# Rezoning Transportation Analysis

Petition Number: 2020-023

General Location Identifier: Tax ID 05321119

Date	Description
03-20-20	First Review
05-27-20	Second Review
06-24-2020	Third Review (KP)

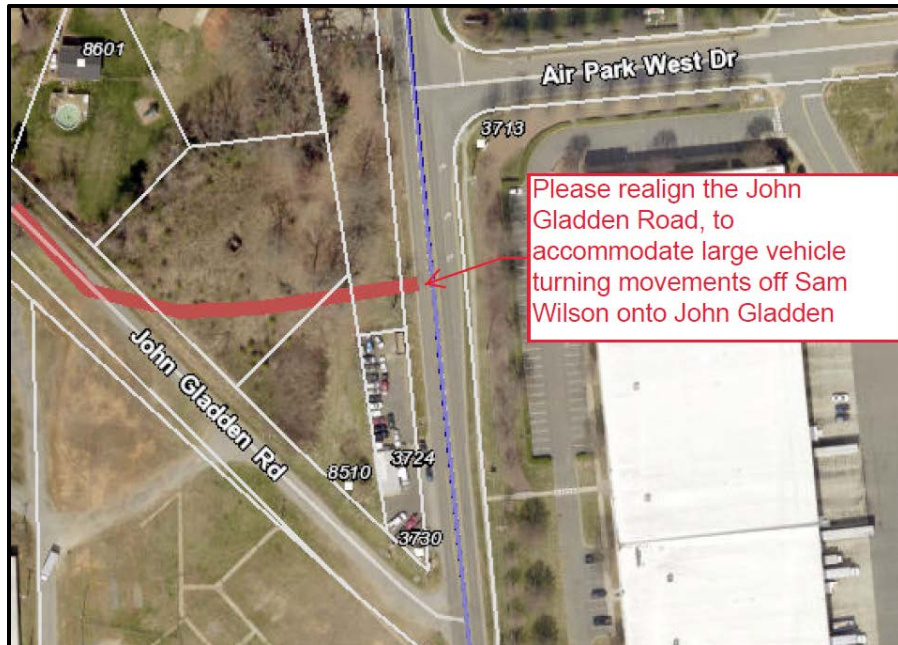
- a. ~~**John Gladden Road:** The future location of curb and gutter is recommended to be placed 17.5 feet from existing road centerline, per Charlotte Land Development Standards Manual (CLDSM) U-06 Local Industrial Street Typical Section. This is an ordinance requirement.~~

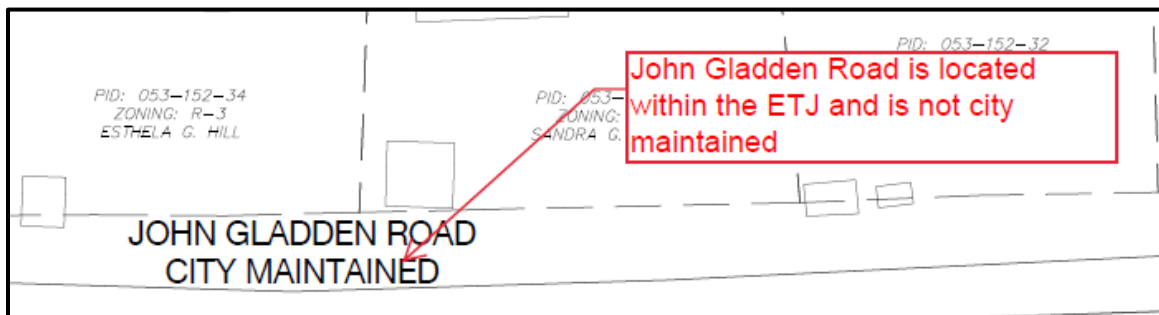
7. The petitioner should revise the site plan to remove the "city maintained" label under John Gladden Road. This road is not maintained by NCDOT and may either be privately maintained or unmaintained.

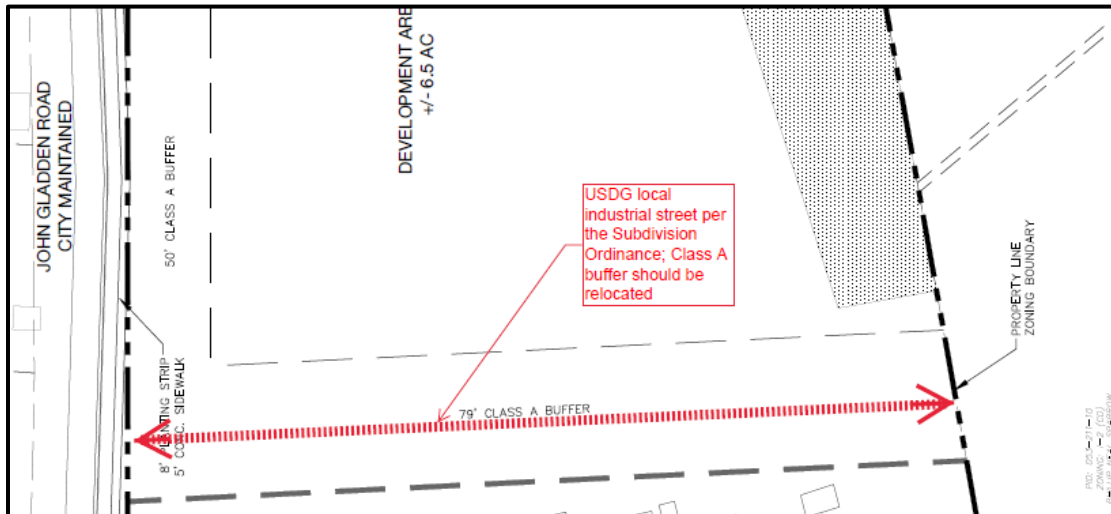
8. ~~The petitioner should revise the site plan and conditional note(s) to include a Subdivision Ordinance required public street, designed per CLDSM std. no. U-06 — Local Industrial Street, as shown below.~~
